April 11, 2011
U7-C-NINA-NRC-110059

South Texas Project
Units 3 and 4
Docket Nos. 52-012 and 52-013
Supplemental Response to Request for Additional Information

RAI 03.07.01-2, Supplement 2**QUESTION:**

Figure 3H.8-9: Target vs. Computed Response Spectra, H2 Component, 2% Damping

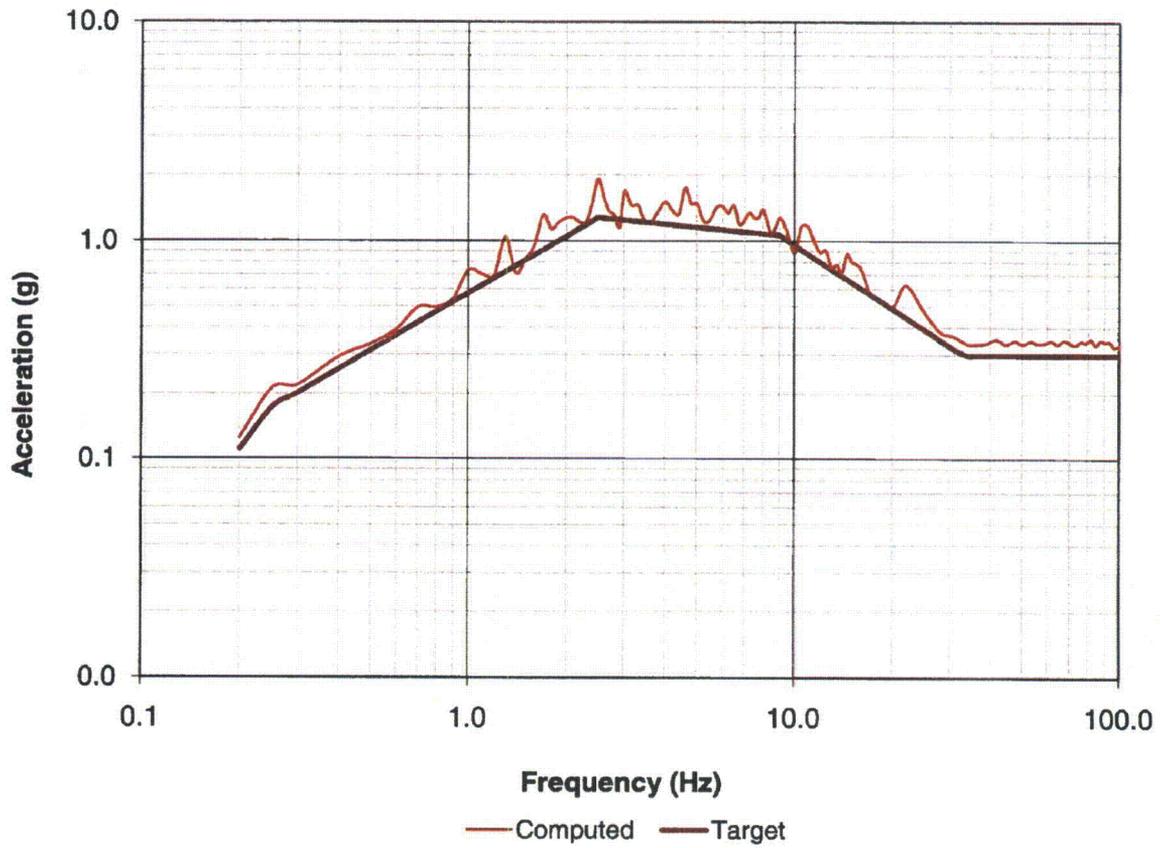
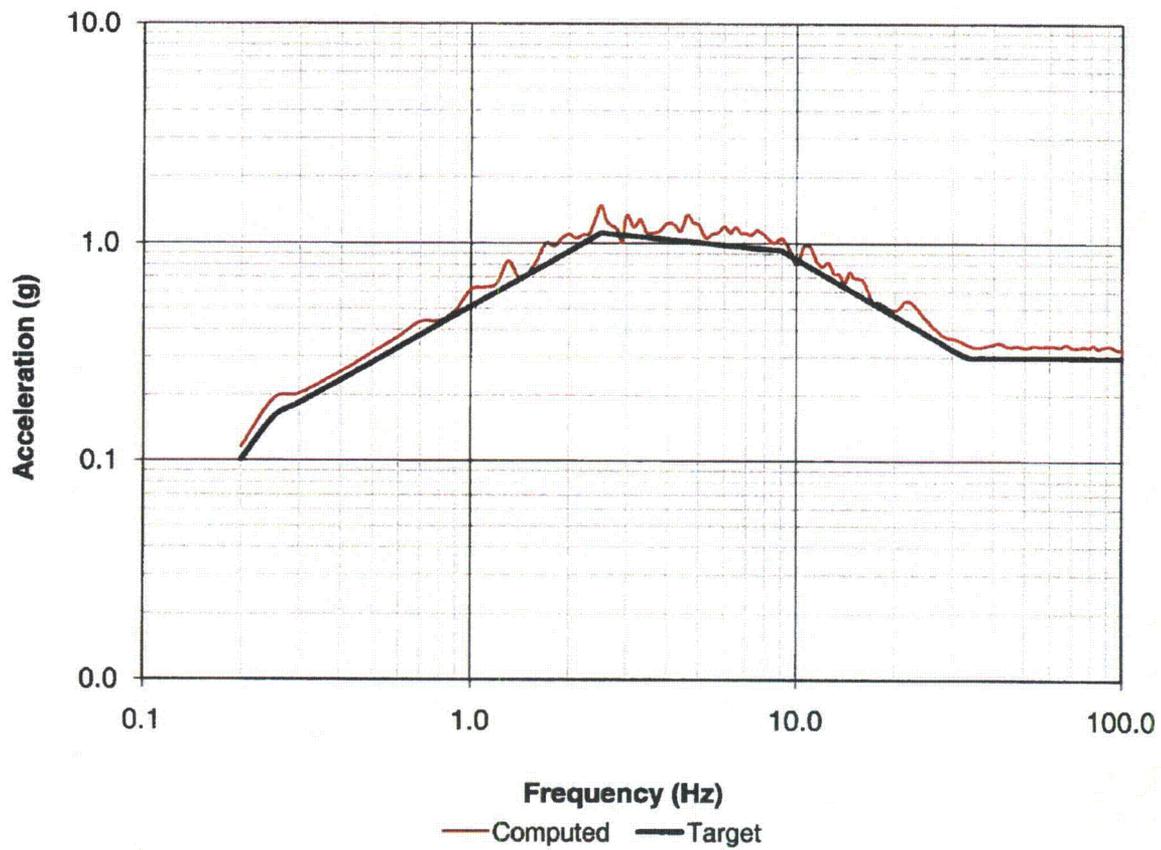
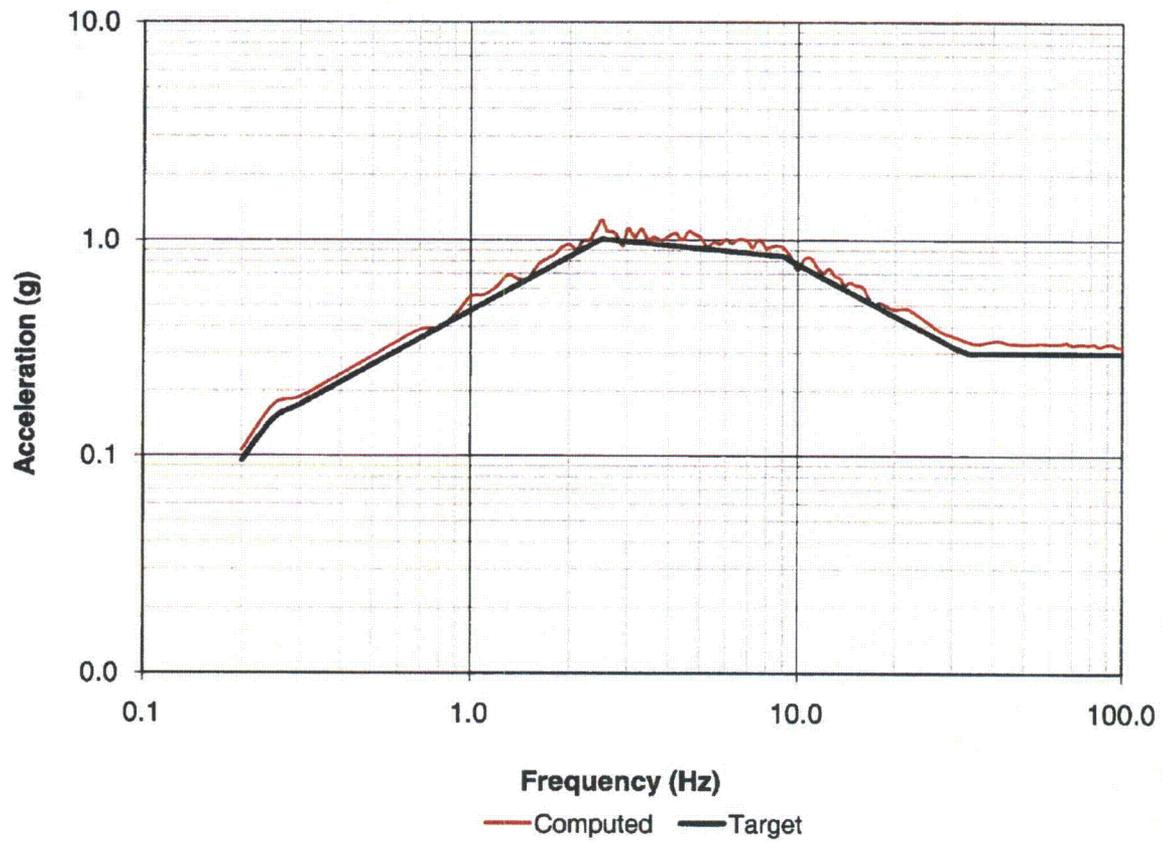
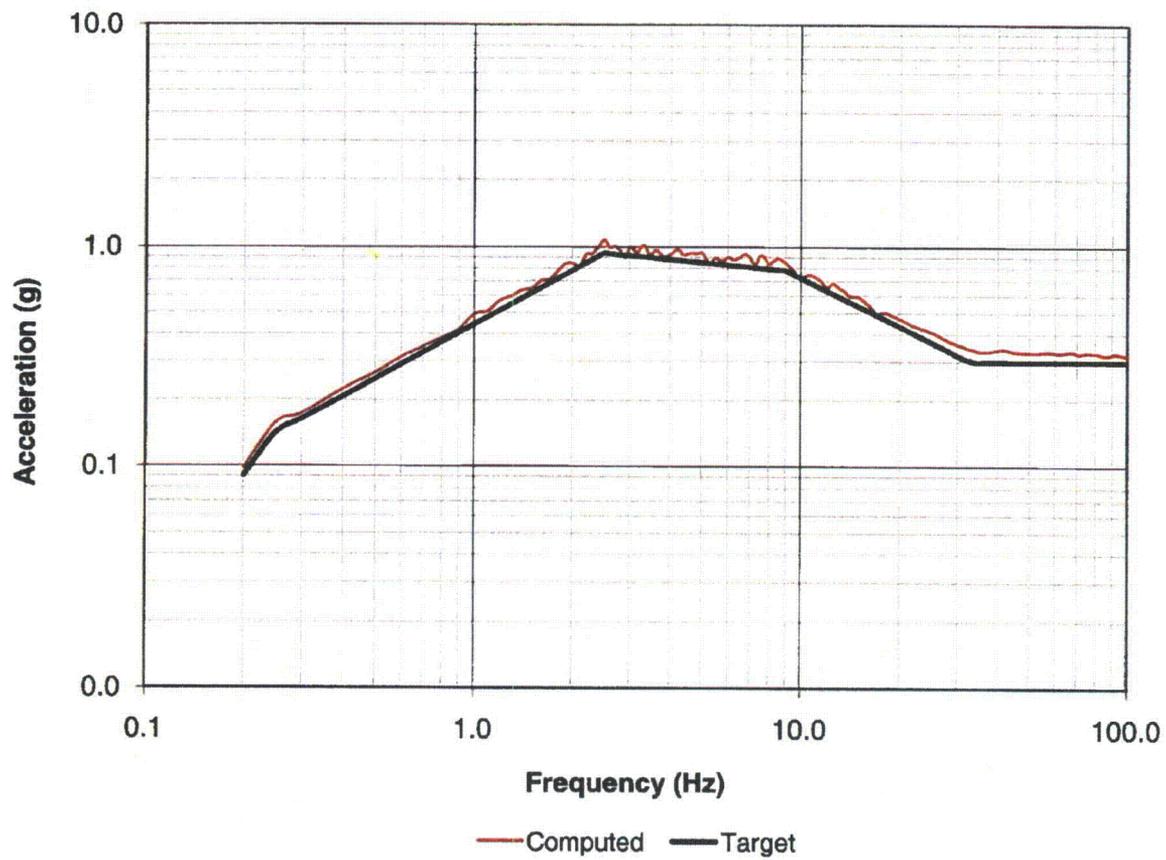
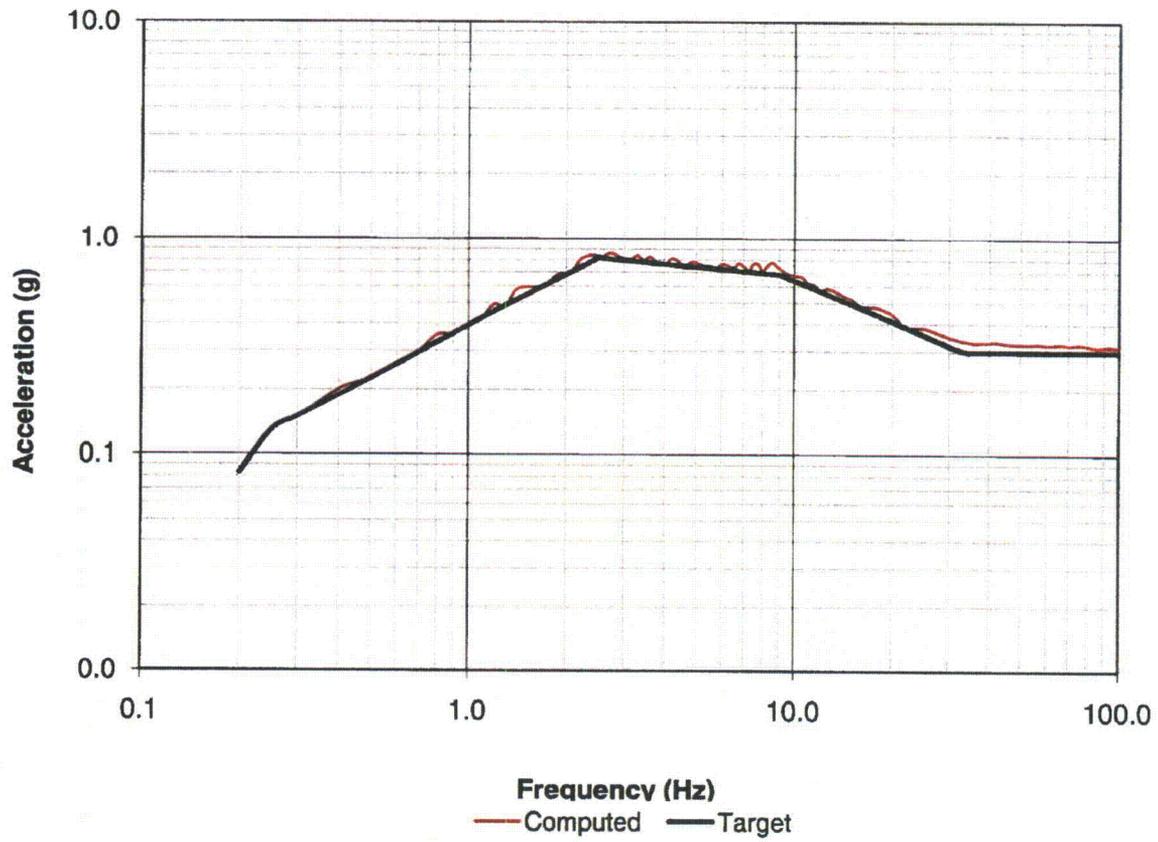
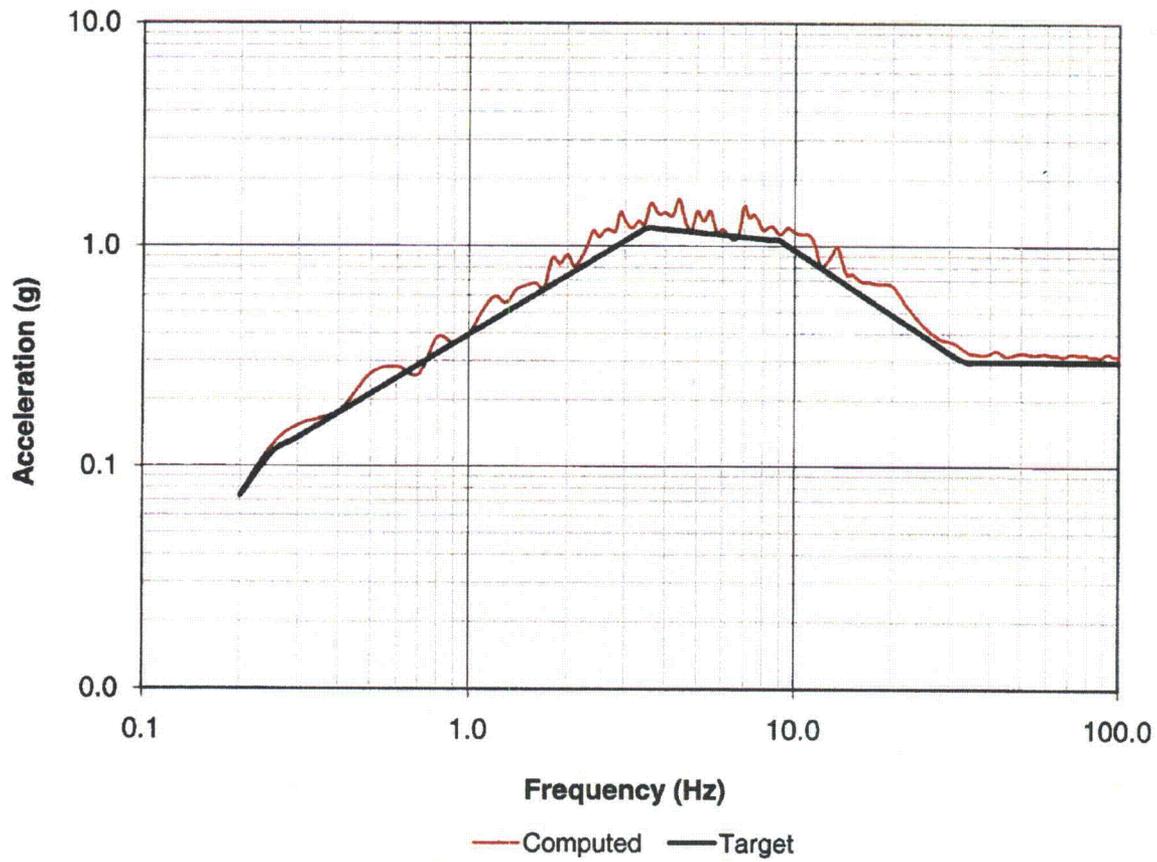
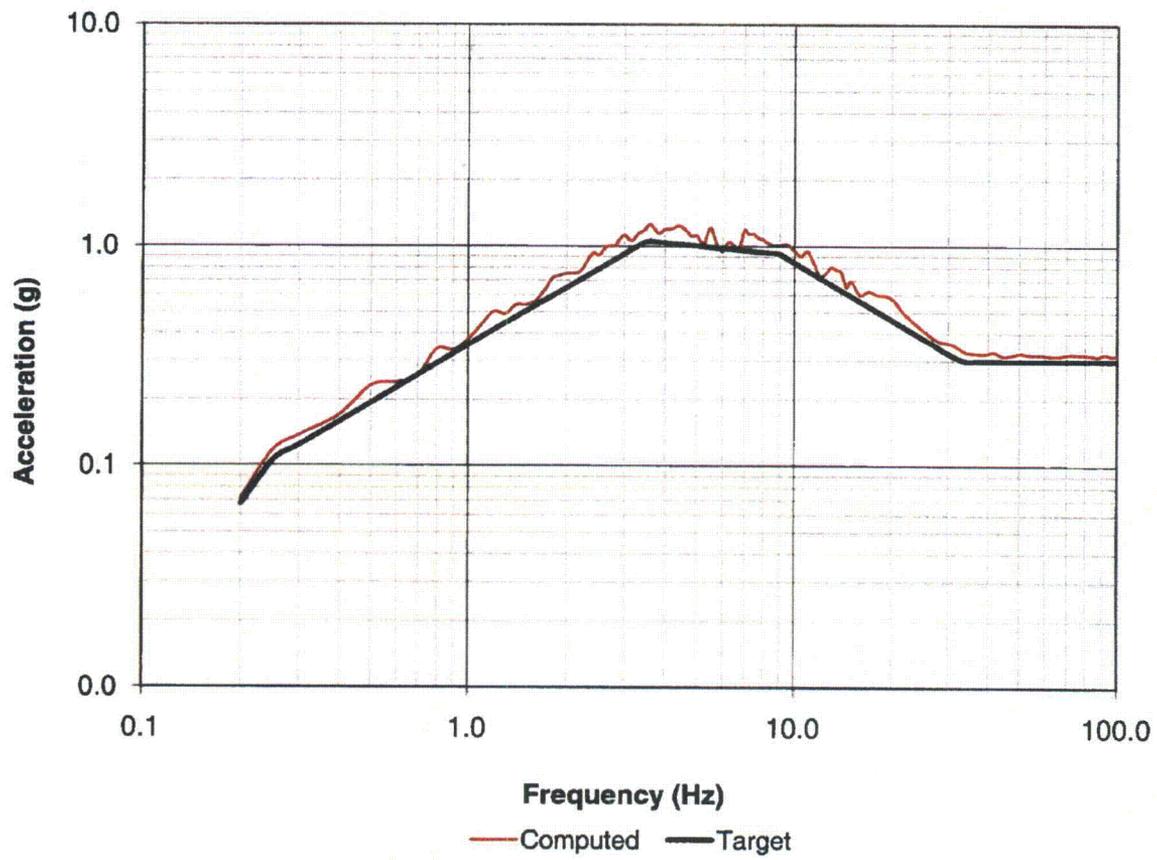
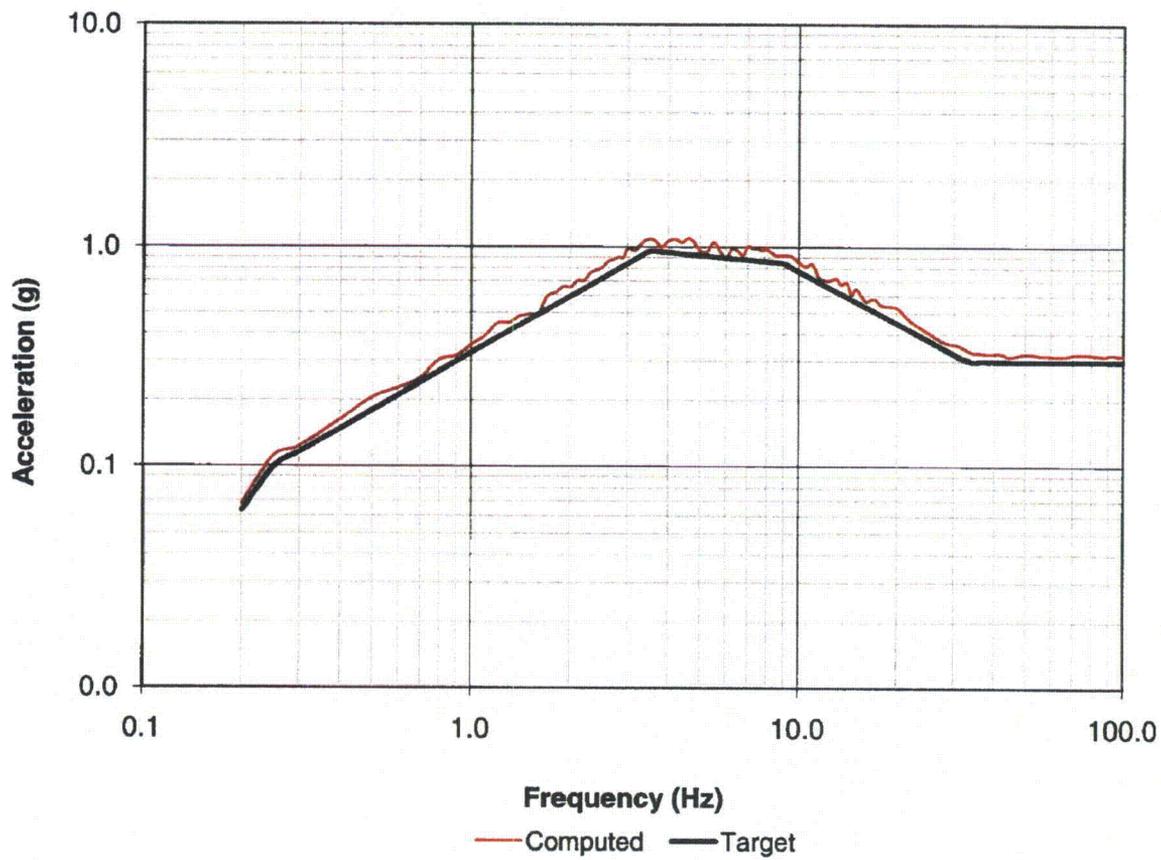
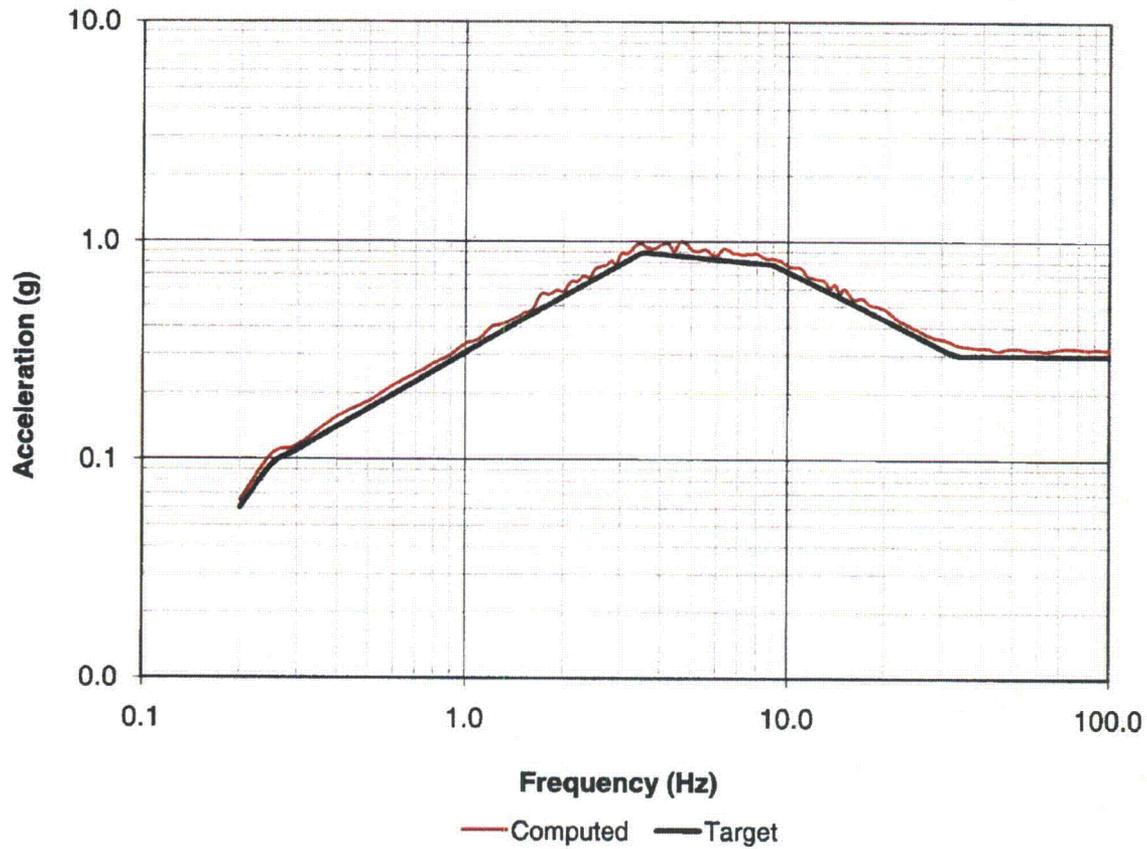
1. Site-specific SSE design response spectra for all applicable damping values (include specific figures) used for seismic reconciliation with the standard plant results as well as for site-specific seismic analysis and design of applicable site-specific structures (Ultimate Heat Sink, and Reactor Service Water (RSW) Piping Tunnel.)
2. Site-specific statistically independent three components of SSE design time histories and their bases that apply for the site-specific analysis.
3. Site-specific Operating Basis Earthquake (OBE) to be used for setting up the seismic instrumentation (FSAR Section 3.7.4).

The original response to this RAI, submitted with letter U7-C-STP-NRC-090105, dated August 20, 2009, provided information on the site-specific Safe Shutdown Earthquake (SSE) time histories. In the seismic analyses performed for the Diesel Generator Fuel Oil Tunnel and Diesel Generator Fuel Oil Storage Vault, consistent time histories for the Certified Seismic Design Response Spectra are required. These time histories were developed and subsequently reviewed during the NRC Audit of March 14-18, 2011. The NRC Staff requested that information on these time histories be added to the COLA to reflect the analysis performed for the Diesel Generator Fuel Oil Tunnel and Diesel Generator Fuel Oil Storage Vault.

The seismic analysis of the Diesel Generator Fuel Oil Storage Vaults and Diesel Generator Fuel Oil Tunnels use the SSE ground motion included in Tier 1 Table 5.0, in addition to the site-specific SSE ground motion, as described in Sections 3H.6.7 and 3H.7, respectively. Since the DCD does not include the digitized information for the SSE time histories, new time histories consistent with Regulatory Guide 1.60 response spectra anchored to peak ground acceleration of 0.3g were developed for use in these analyses. Acceleration time history records obtained from 1994 Northridge Earthquake were used as seed time histories in generating these synthetic time histories. The time histories were developed in accordance with the criteria described in Section 3.7.1.2, using computer programs SYNQKE-R, HIST, and QUAKE described in Appendix 3C.

The plots of the acceleration, velocity, and displacement time histories of the two horizontal and the vertical components are shown in Figures 3H.8-1 through 3H.8-3. The plots of response spectra for 2%, 3%, 4%, 5%, and 7% damping, showing the comparison of the target response spectra (Regulatory Guide 1.60 spectra) with the spectra of the synthetic time histories, are shown in Figures 3H.8-4 through 3H.8-18. The plots of power spectral density functions (PSD) showing the comparison of the target PSD, corresponding to the Regulatory Guide 1.60 spectra, with the PSD of the synthetic time histories are shown in Figures 3H.8-19 through 3H.8-21.
